DOCUMENT CHANGE REQUEST

DCR number	593	Changes required for:	General	Originator:	Jean-Laurent BOUTEAUX
Date:	2010/04/21	Date sent:	2010/04/21	Organisation:	CNES
Status:	IMPLEMENTED

Title:	Connectors Miniature Electrical Circular Triple-Start Self-Locking Coupling Scoop-Proof Hermetic
--------	--

Number:	3401/057	Issue:	2
---------	----------	--------	---

FIGURE 2(b) – SPECIAL CONTACT ARRANGEMENTS – FRONT VIEW MALE INSERT (3)

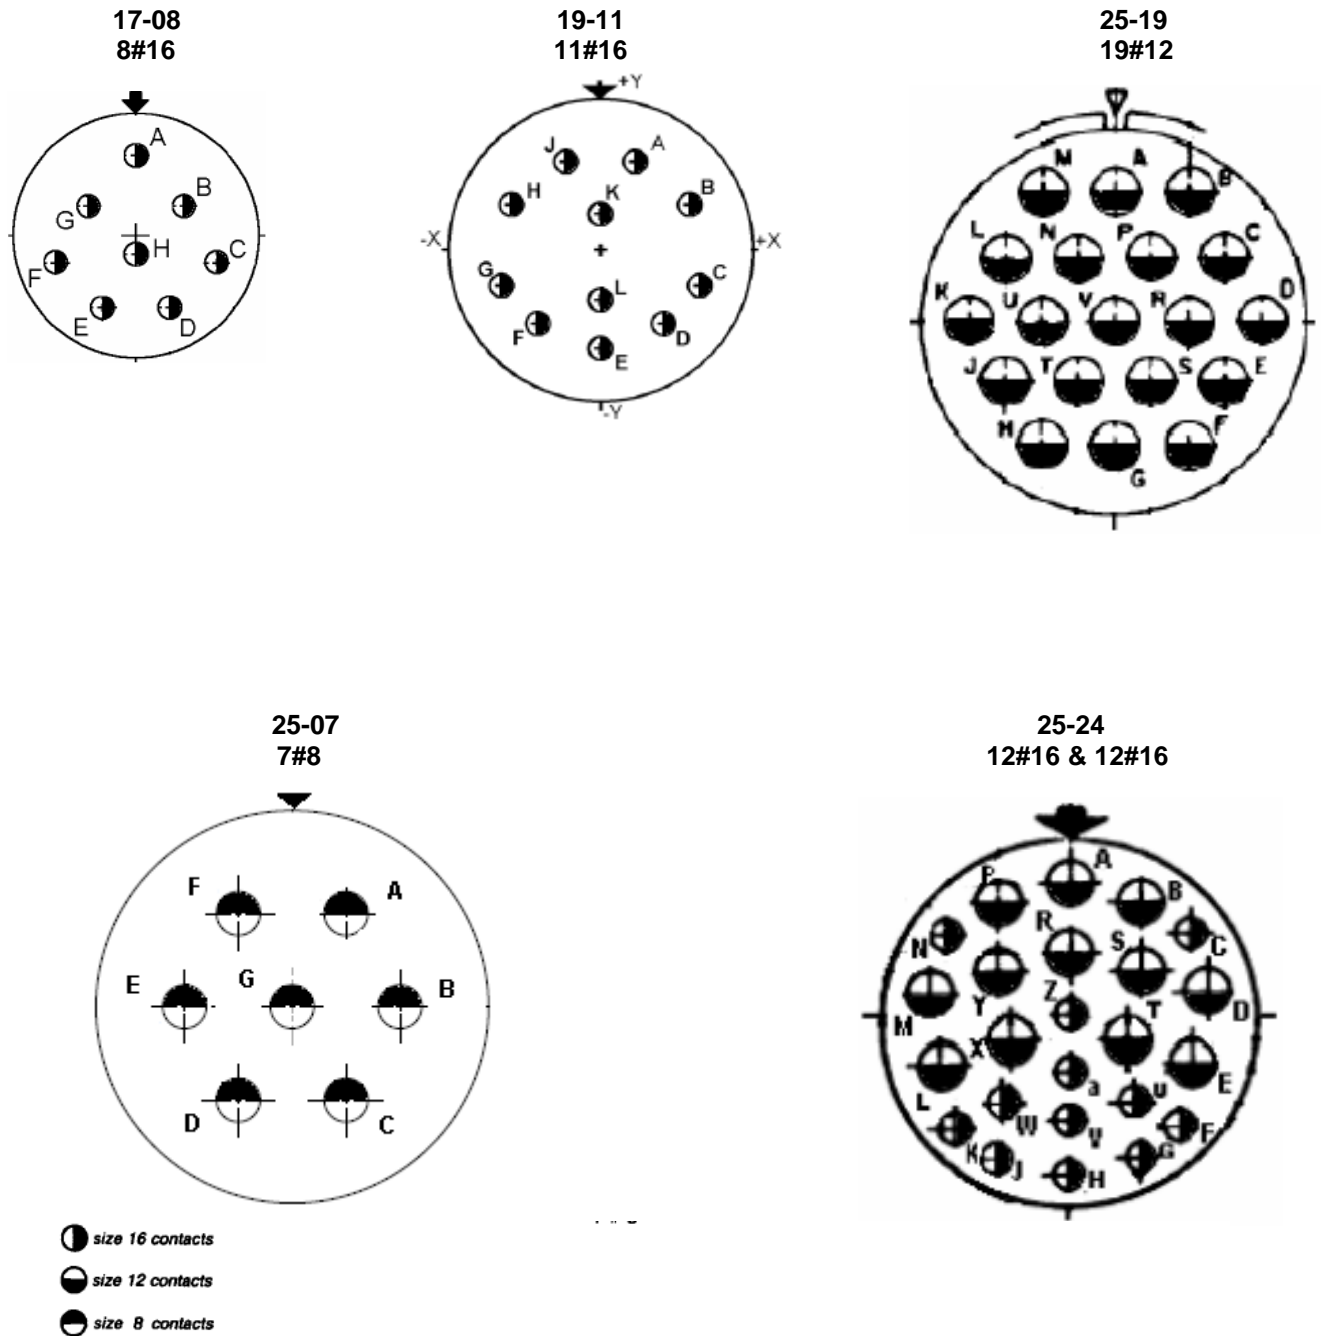
Page 13 "Special contact arrangements"
Add 25-24 (12 #16 & 12 #12)
Page 19 Â§ 4.5.4.3 Contact arrangements
Add 25-24 Service Rating II

Extension of the contact arrangements range available further a customer request.
Contacts size 16 are already qualified in arrangements 17-08 and 19-11, contacts size 12 in the arrangement 25-24. In the next maintenance of qualification, there will be samples with 25-24 arrangement.

The attachment (page 13) to be corrected:

25-24 arrangement

It should read:

25-24

12 #12 & 12 #16
